KEYSTONE XL PIPELINE PROJECT

0269-SD-P4-311-3-311.5-1

KEYSTONE XL PIPELINE PROJECT ROUTE VARIATION AUTHORIZATION FORM		
Date: 3/19/2012	Tracking Number: 0269-SD-P4-311.3-311.5-1	MP: 311.3 to 311.5
Description: The primary reason for this reroute is to avoid Cultural Site (CBRAVOHA001). Smith #36HN1133.	Originated By: Environmental	Variation Form Attached: Yes <input type="checkbox"/> X No <input type="checkbox"/>
TransCanada - Land Tina Hall	Variation: Approved <input checked="" type="checkbox"/> Rejected <input type="checkbox"/>	Date: 4-16-12
Comments:	If Rejected Why?	
TransCanada - Engineering Meera Kothari	Variation: Approved <input checked="" type="checkbox"/> Rejected <input type="checkbox"/>	Date: 8/22/12
Comments:	If Rejected Why?	
Exp - Engineering Butch Wallace	Variation: Approved <input checked="" type="checkbox"/> Rejected <input type="checkbox"/>	Date: 3/22/2012
Comments:	If Rejected Why?	
Exp - Environmental Jonathan Minton	Variation: Approved <input checked="" type="checkbox"/> Rejected <input type="checkbox"/>	Date:

Proposed Route Variation 0269-01

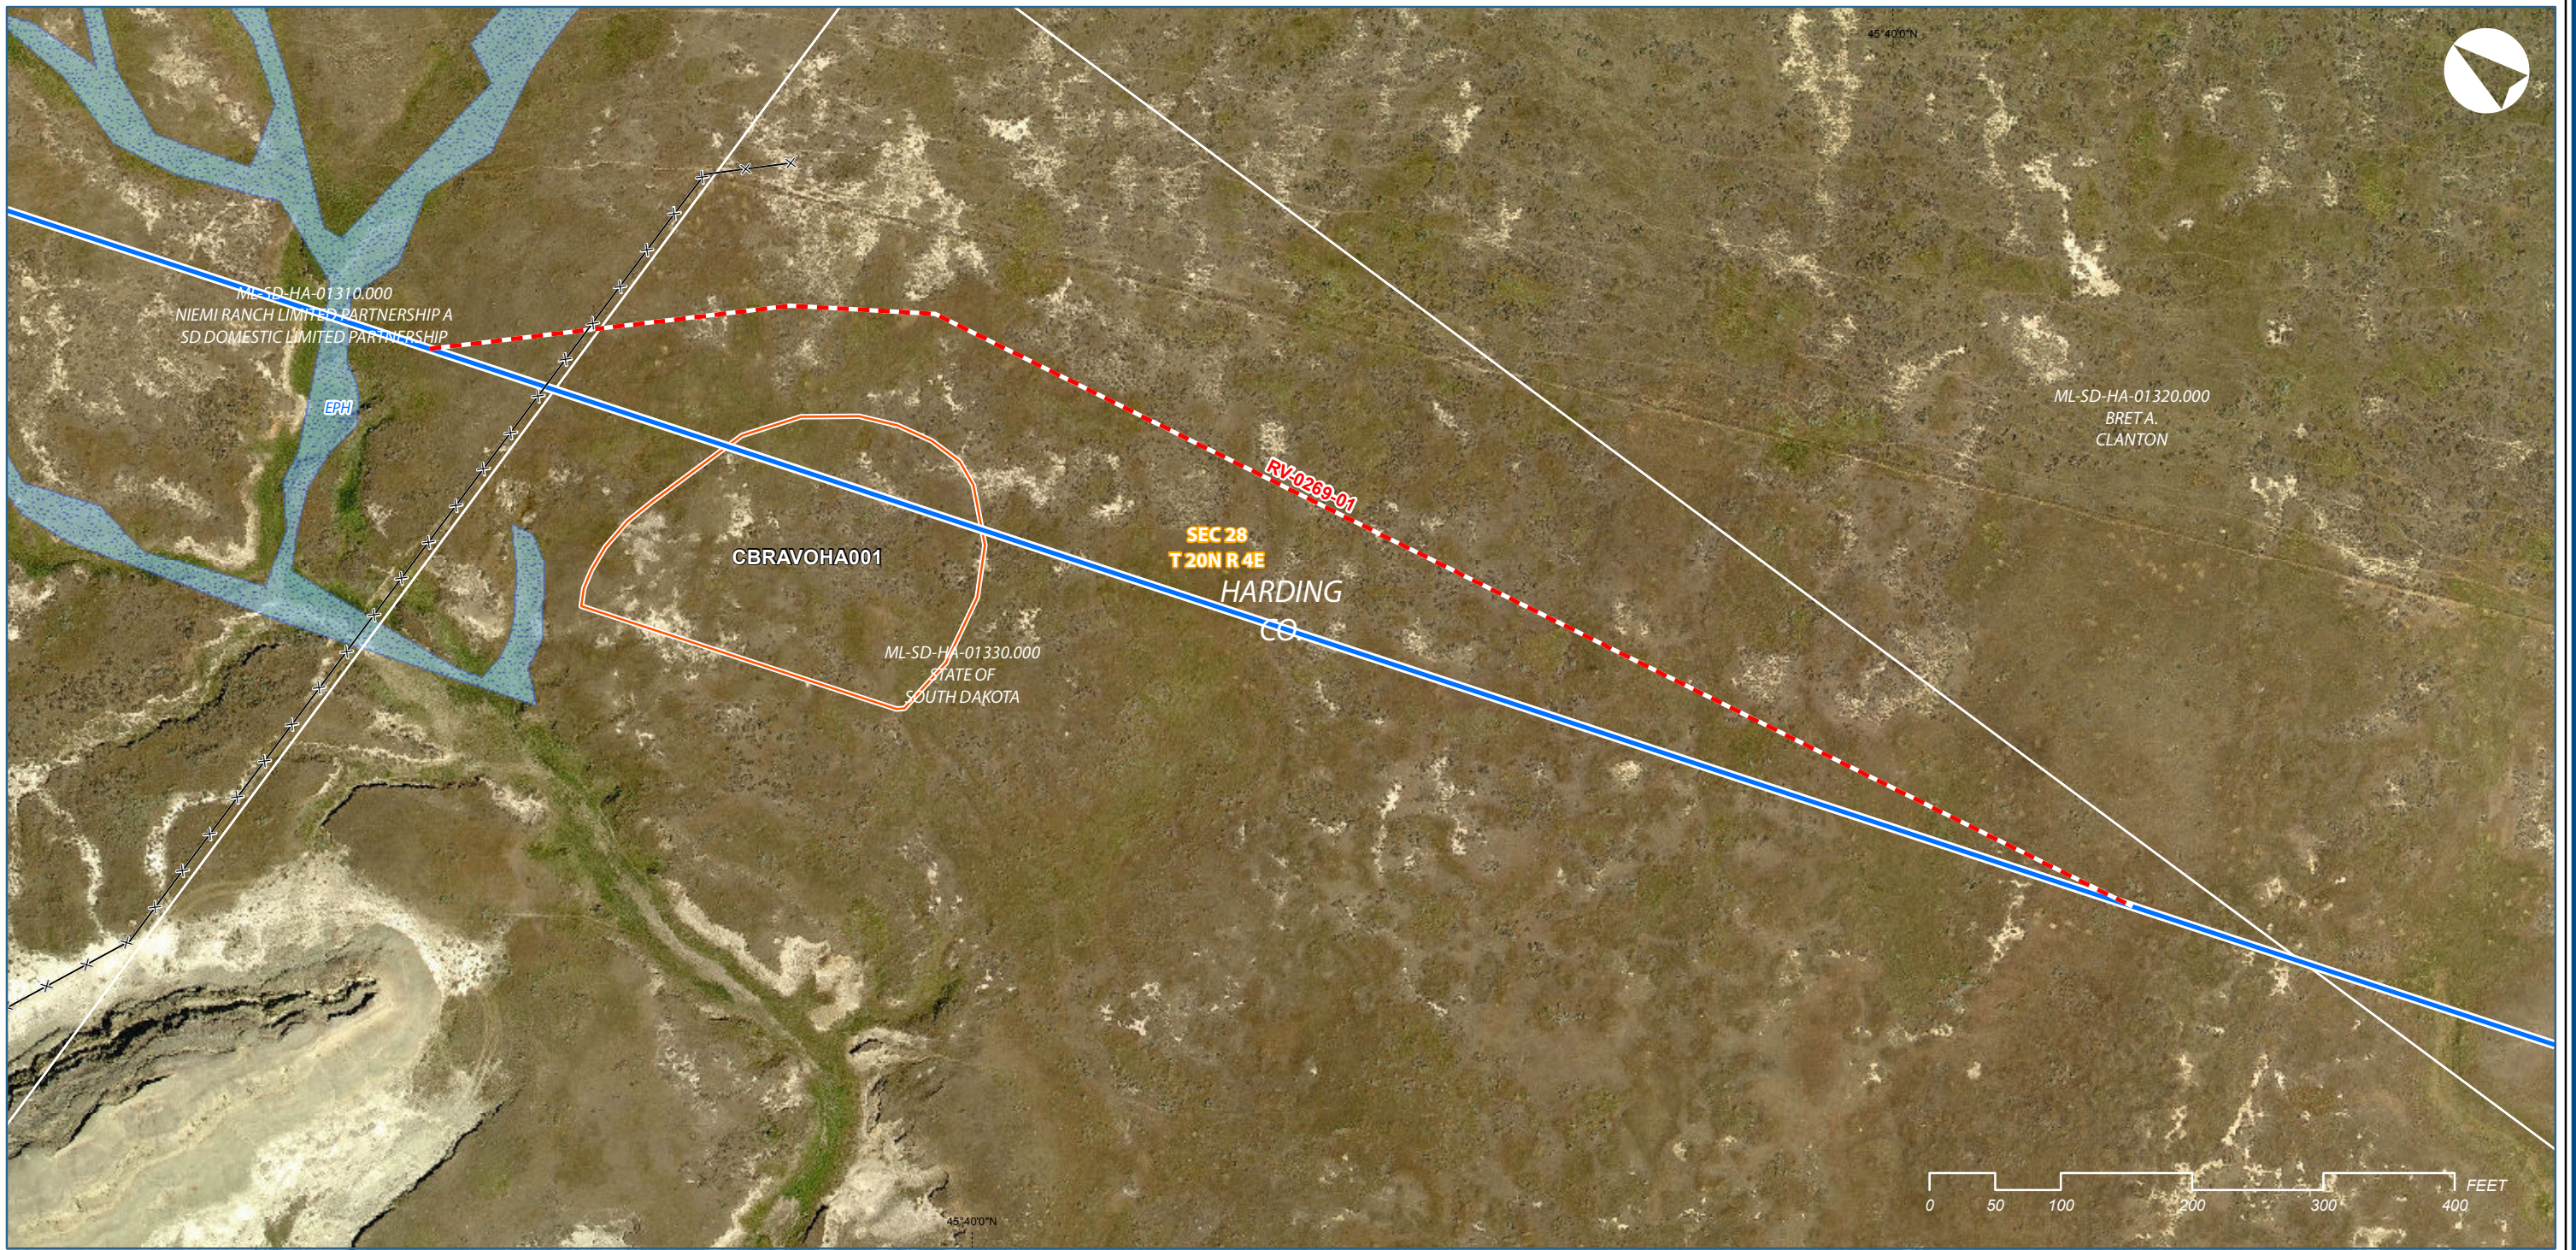
DETAIL ROUTE VARIATION (Please describe route variation in detail): Route variation starts near MP 311.3 and deviates ~25.5° east of current C/L. It extends in this direction for ~277 ft. Then it turns further east and continues in this direction for ~111 ft and thus avoids the cultural site and allows for all temporary workspaces to avoid it as well. Lastly, the reroute turns south for ~1,019 ft. to rejoin the C/L near MP 311.5.			
ADDITIONAL IMPACTS (Please include any additional impacts which may affect cost; crossings, induction bends, etc.): No New Landowners are impacted by this route variation. Reroute Impacts 2 tracts: ML-SD-HA-01310.000 (Niemi Ranch Limited Partnership A SD Domestic Limited Partnership) ML-SD-HA-01330.000 (State of South Dakota) The reroute increases pipe length by ~ 60 ft. Miscellaneous Cost savings include: ~\$15,000-\$20,000 to test the site, ~20,000 - 25,000 for treatment/mitigation.

a) Maximum deviation perpendicular to proposed alignment: 145 ft.
